**ADDENDUM NO. 3
TO THE BID DOCUMENTS
FOR THE
ATCT RENOVATIONS PHASE II- GLASS REPLACEMENT
BOCA RATON AIRPORT
BOCA RATON, FLORIDA**

**ADDENDUM NO. 3
TO THE BID DOCUMENTS
ATCT RENOVATIONS PHASE II- GLASS REPLACEMENT
BOCA RATON AIRPORT
BOCA RATON, FLORIDA**

Addendum #3 – Bidder's Questions

STOREFRONT WINDOW HEAD @ CAB W/ SHADE ROLL

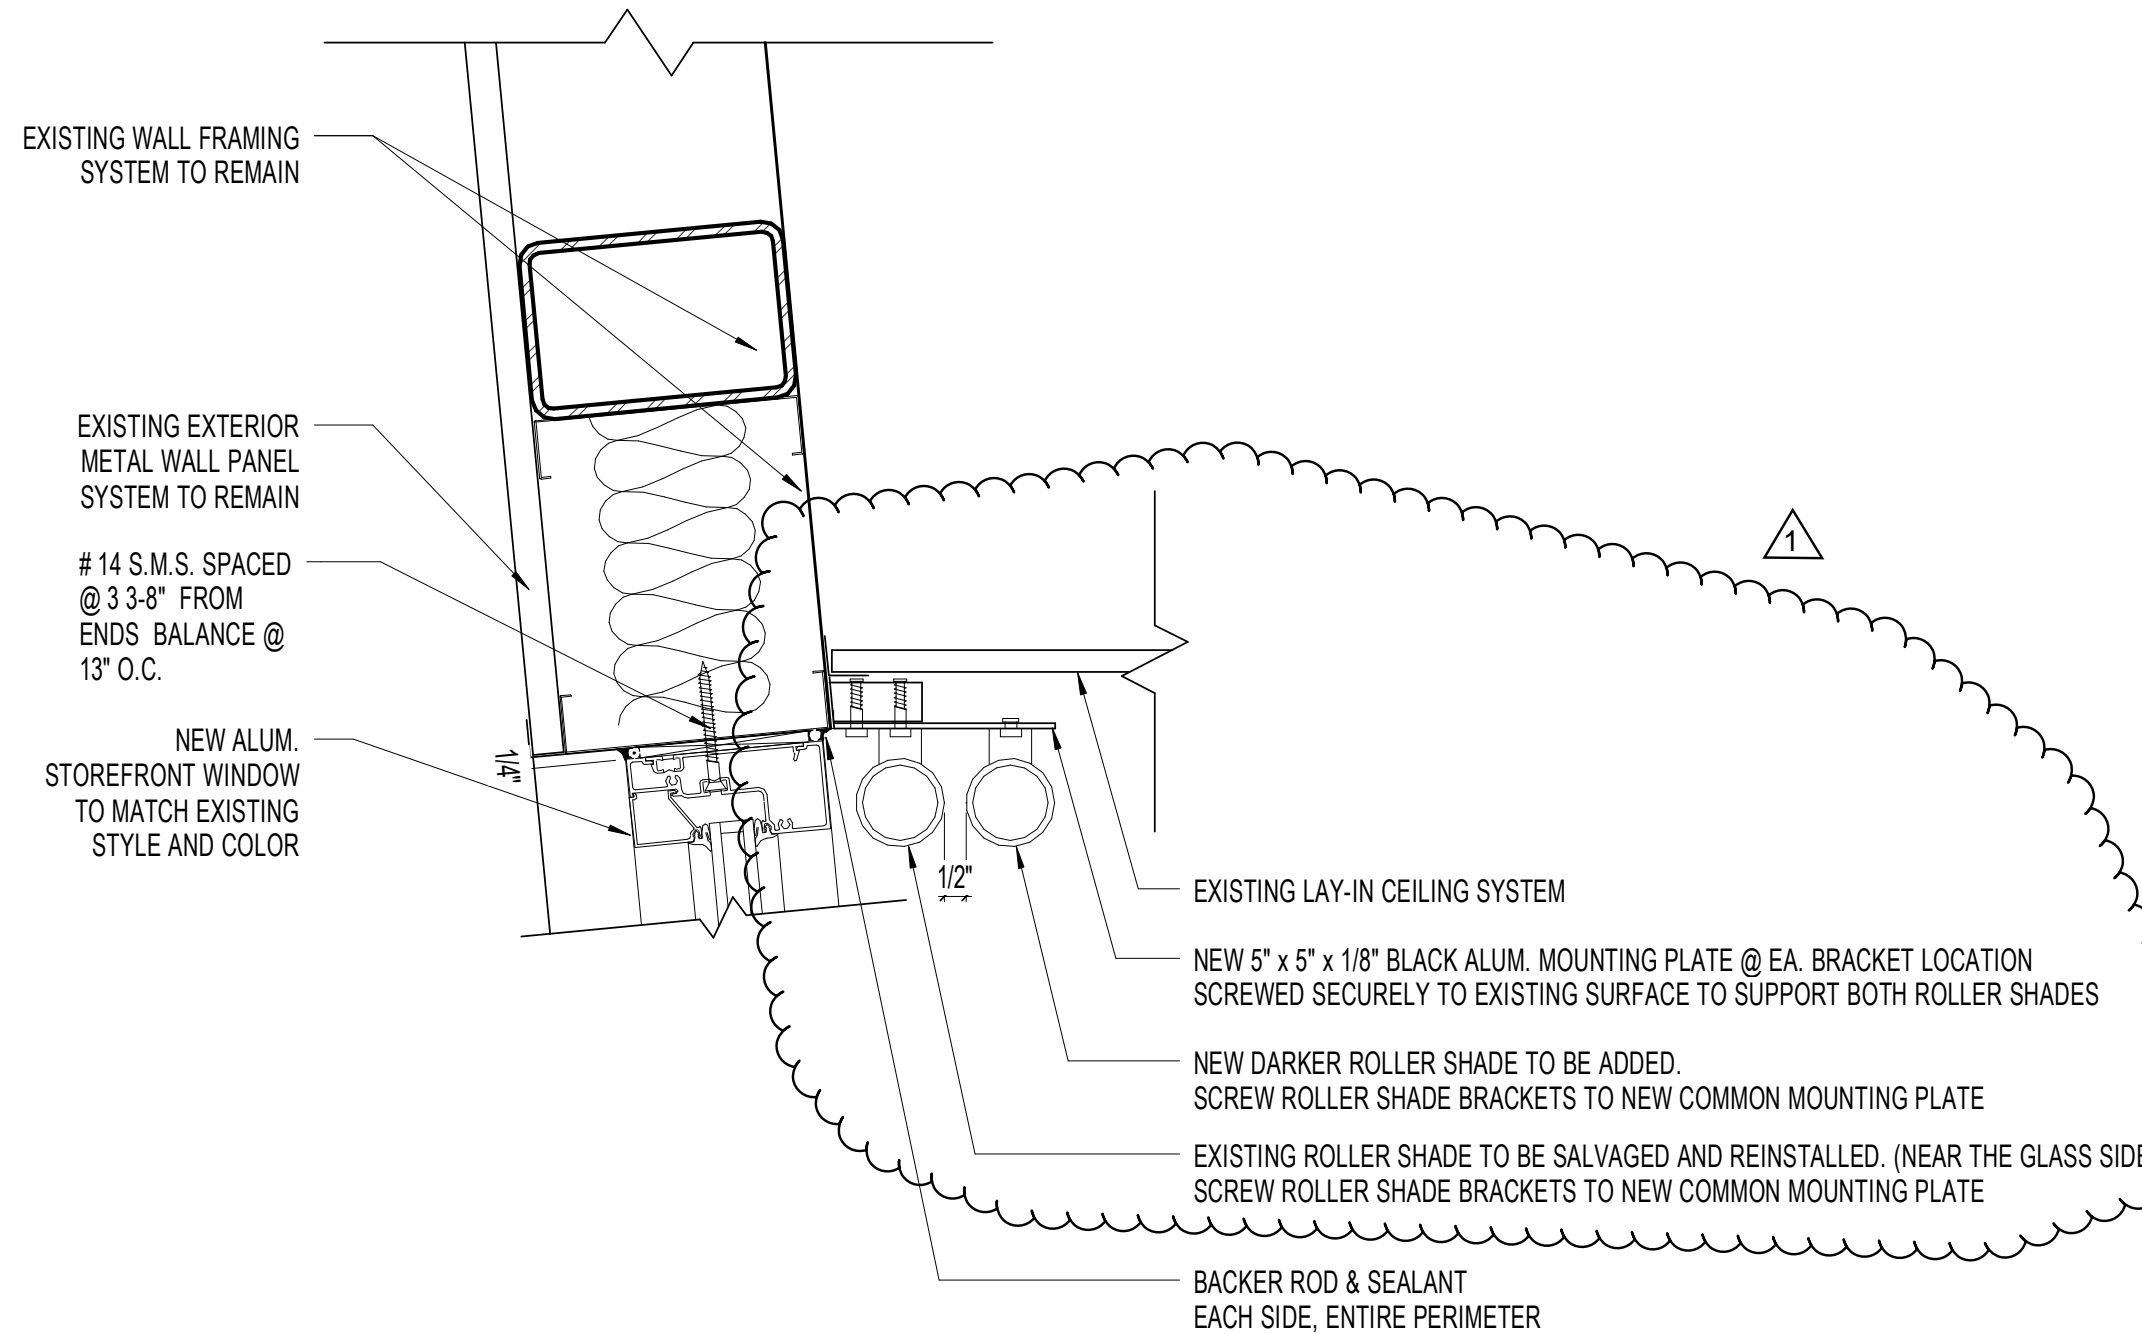
Q3: Since a new pocket will force the repositioning of the shade mounting, the shades currently in place will need to be cut down in the field to fit, if they wouldn't be too small to begin with. The labor cost for the adapting of 12 shades would be more than a new set. The shades currently in place are now 7 years old. The service period for these shades are 5 - 8 years. It's not worth fitting a set that old.

Q4: We would recommend that full width shades be used to avoid a center gap light leak between 2 shades. However, the span noted on page A651.1 shows a width of more than 13'. Understanding that the pocket will be slightly smaller (but unsure exactly), the widest our shade tubes can go is 12'. If the bisecting points of the pocket are 12'- 4" or less, by

A: Per this addendum, the shade pocket scope is deleted and Detail 3/A651.1 for the shade pocket is deleted and replaced with the attached detail 3/A651.1. The existing shades will be removed temporarily to avoid damage and facilitate installation of the new replacement windows. The shades will then re-installed in the same location with the original mounting hardware attached to a new mounting plate as shown in the revised 3/A651.1 detail. Shades need to be in place for Tower use at the beginning of each day. A second set of darker secondary shades will be mounted next to the existing shades with similar mounting hardware attached to the new mounting plate as shown in the revised 3/A651.1 detail.

A: Side by side shades to match existing will be necessary. The gap needs to be 1/4" max to match existing. The width of the top mullion of the window pair is approximately 13'-2" with a center mullion at approximately 6'-7" width. The existing shade rollers currently cover the 6'-7" width of each individual glass lite, resulting in (2) shades covering each window pair for the 13'-2" opening. The new secondary shades will match the existing primary shade sizing in the same way, with one roller shade for each individual glass lite, with a small 1/4" gap between the two window shade rollers at the center mullion
